# City of San Antonio

Re: Hunter's Pond Subdivision (Amendment)

**MDP # 801-B**

The City Staff Development Review Committee has reviewed the Hunter's Pond Subdivision Master Development Plan **MDP# 801-B (amendment)**. Please find enclosed a signed copy for your files. Your plan was approved for acceptance, however, please note the following conditions:

HUNTER'S POND SUBDIVISION, T.I.F.  
MASTER DEVELOPMENT PLAN  
"URBAN DEVELOPMENT PLANNING DISTRICT"  
97.67 ACRES

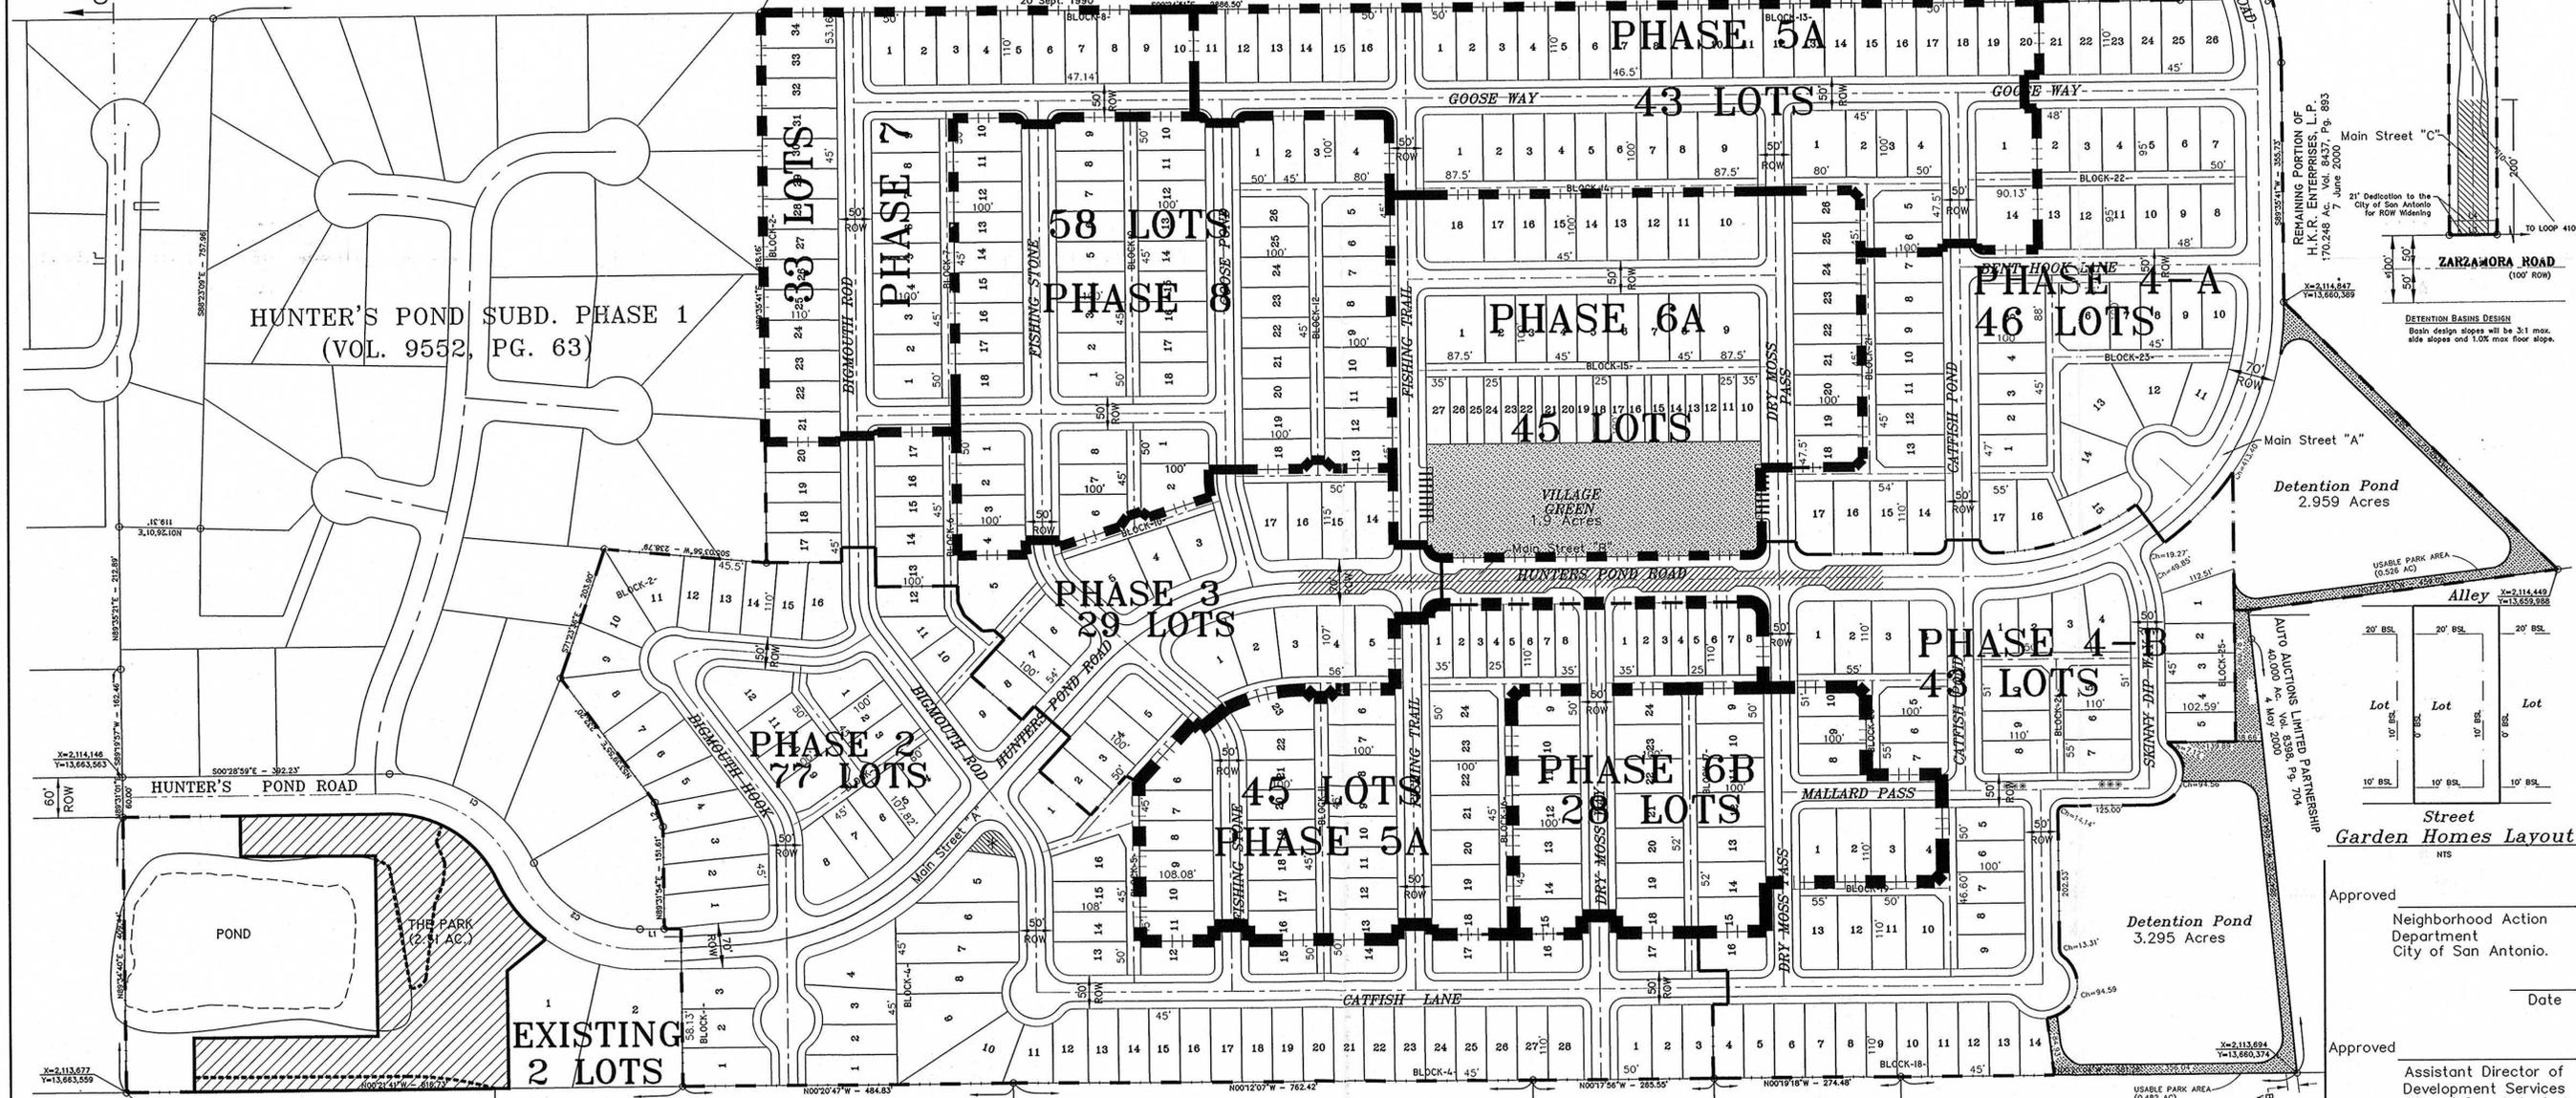
- The Developer shall provide 71 feet of ROW from the centerline of Zarzamora (Enhanced Secondary Arterial) adjacent to this proposed project.
- Construction of an internal Main Street roadway system based on Urban Development (UD)/Traditional Neighborhood Development (TND) design standards. No houses shall front on the proposed Main Street shown except where alley access is provided to such lots. This street approval is in accordance with UDC 35-506, Table 506-4 Traditional Street Design Standards.

- All Roadways shall conform to Table 506-2: Functional Classification System Description.
- Right turn deceleration lane shall be constructed on southbound Zarzamora to the proposed collector. This construction may require dedication of additional right-of-way.

- Right turn deceleration lane shall be constructed on eastbound Loop 410 Frontage Road to southbound proposed collector. The right turn lane is required based on TXDOT

Access Management Principles and Roadway Design Applications Manual. This construction will require concurrence from the Texas Department of Transportation for construction within its right-of-way.

- Secondary Access – UDC 35-506, (e), (7) shall be implemented at the time of platting.
- The on-site improvements referenced on the approval letter for MDP# 801-A dated July 18, 2006 still apply.

Hunter's Pond has a park dedication requirement of 6.6 acres (459/114) which will be met through a combination of parkland and improvement credits.

- A 2.51 acre neighborhood park shall be created at the northern entrance to the subdivision and will include a minimum of three items from the Parks and Recreation System Plans Neighborhood Park facilities list.
- A 1.9 acre Green, centrally located within the subdivision
- Two 30,000 square foot open play areas located in the Green for a credit of 2.75 acres. Play areas to meet the requirements set forth in Table 503-4 of UDC 35-503.
- UDC regulations regarding phasing and maintenance must be followed as detailed within UDC 35-503 and shall be monitored throughout the platting stage.

- This development may need to comply with tree preservation ordinance #85262.

- Hunter's Pond Road is identified as a collector with 70 feet of ROW. The configuration shown may create operational problems on the collector due to necking down to 24 feet of pavement.

- Plans shall indicate ROW on Zarzamora. Enhanced Arterial ROW shall be 142 feet. Developer shall provide 71 feet of ROW from Centerline of Zarzamora.
- Intersection sight distance should be used for all intersections.
- It is understood that this MDP is a conceptual plan and all regulations will be addressed at time of platting. Bexar County reserves the right to address driveways, street design, sight distance, ADA requirements, drainage and floodplain issues at time of platting.
